DCN No. **E990244-00-D**

# DOCUMENT CHANGE NOTICE (DCN)

DOCUMENT No. (DOC-REV-GP. ID)	TITLE	NEW REV.
D990141-C	Cavity Beam Dump Housing Assembly, BSC7, 2KFMXX & 2KFMXY, BSC8, 2KFMYX & 2KFMY	D
D990225-D	Cavity Beam Dump Housing Tube, BSC7, 4KITMXHR3, 4KITMXHR4, BSC8, 4KITMYHR3 & 4KITMYHR4	E
D990252-B	Cavity Beam Dump Housing Tube, BSC4, 2KITMXAR1, 2KITMYAR1, 2KRMHR3, BSC2, 4KITMXAR1 & 4KITMYAR1	C
D990402-n/a	Cavity Beam Dump Housing Assembly, BSC7, 4KITMXHR3 & 4KITMXHR4, BSC8, 4KITMYHR3 & 4KITMYHR4	A
D990403-n/a	Cavity Beam Dump Housing Assembly, BSC2, 4KITMXAR1 & 4KITMYAR1, BSC4, 2KITMXAR1, 2KITMYAR1, & 2KRMHR3	A

CAVITY BEAM DUMP  
 HOUSING ASSEMBLY  
 BSC7, 2KFMXX & 2KFMYY  
 BSC8, 2KFMXX & 2KFMYY

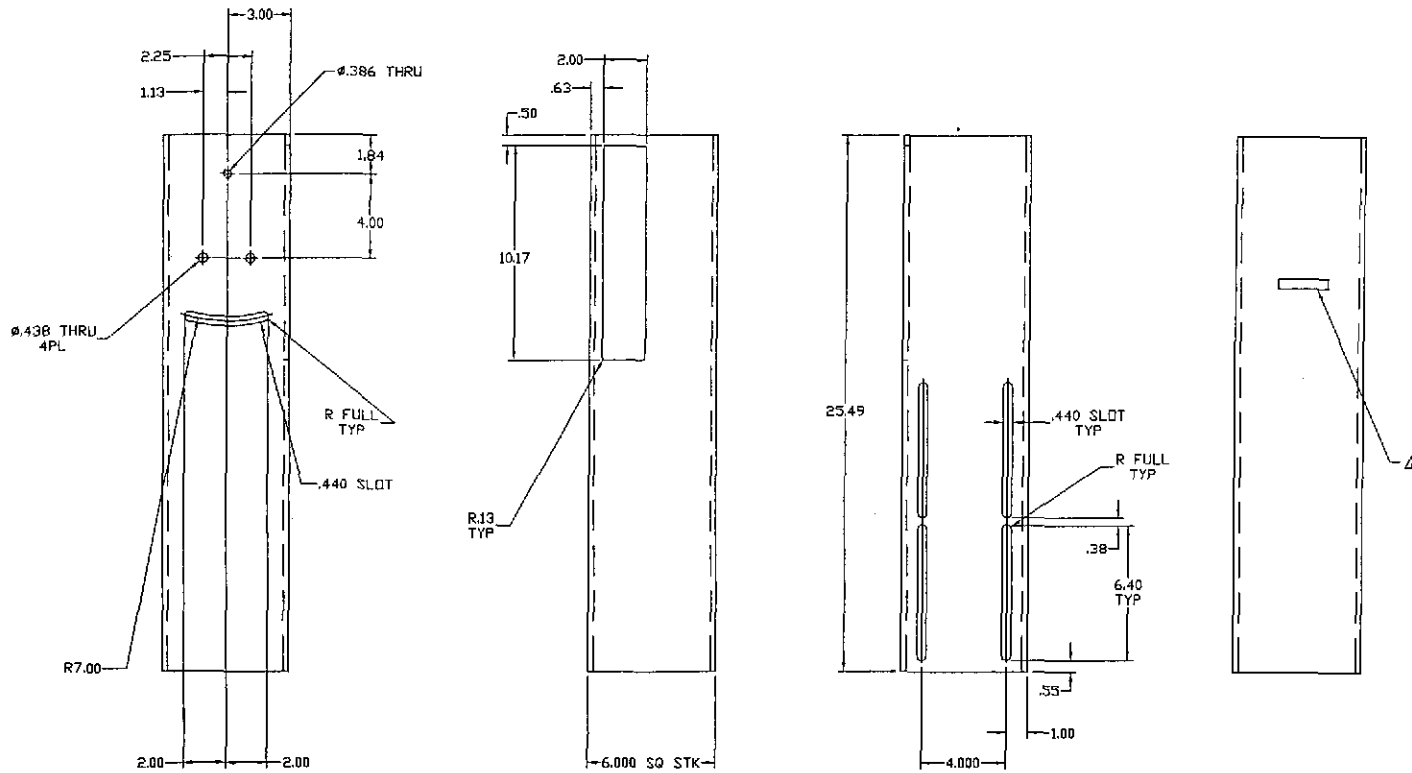
D990141: Changed parts list entry item one from "-" to "D990223" in the part number column.  
 D990225: Changed Next Ass'y block entry from "D990141" to "D990402".  
 D990252: Changed Next Ass'y block entry from "D990141" to "D990403".  
 D990402 & D990403: Initial releases.
